From: ANDERSON, Victoria <vka@nei.org>
Sent: Monday, December 17, 2018 3:31 PM
To: Reisi Fard, Mehdi; Hartle, Brandon
Cc: Rosenberg, Stacey; Casto, Greg; Vasavada, Shilp; Evans, Jonathan; Drouin, Mary; Weerakkody, Sunil; Linthicum, Roy R.:(GenCo-Nuc); KRUEGER, Greg; GEIER, Stephen
Subject: [External_Sender] RE: RE: FYI- Execution of the subset of issues from the standard important to TSTF-505 & NEI-17-07
Attachments: NEI 17-07 R1 Dec 2018.docx

The revised draft of NEI 17-07 is attached. Absent additional comments from NRC, this is the version we plan to use for the newly developed method peer review pilot process.

A revision of NEI 17-07 is attached, as is a comment resolution table. We look forward to discussing on 12/17.

Figure 1-1: Peer Review Process

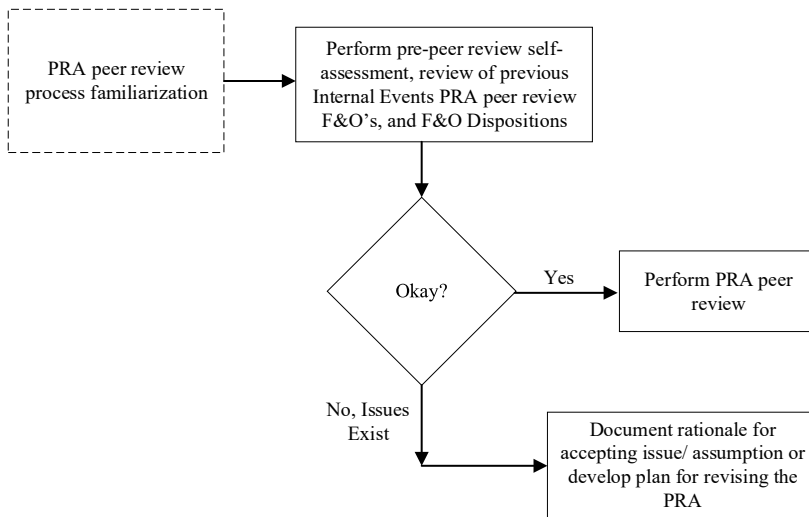
Commented [NRC28]: When issues exist, who is performing the documentation or developing the plan?

Figure 1-2: FPRA Peer Review Process Flow Chart

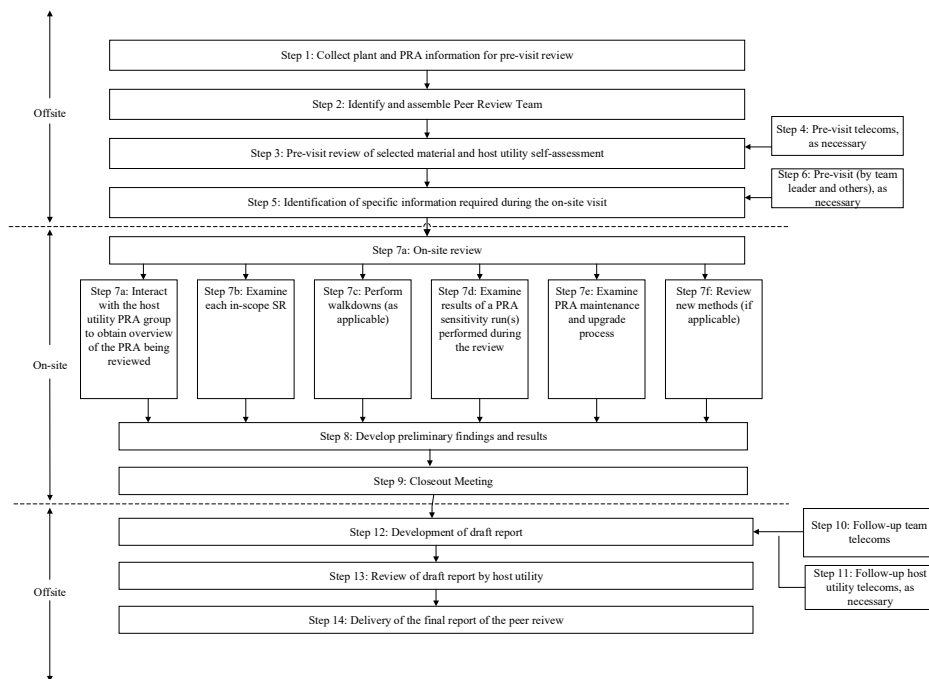
Commented [NRC29]: Title is too similar to Section 5.1
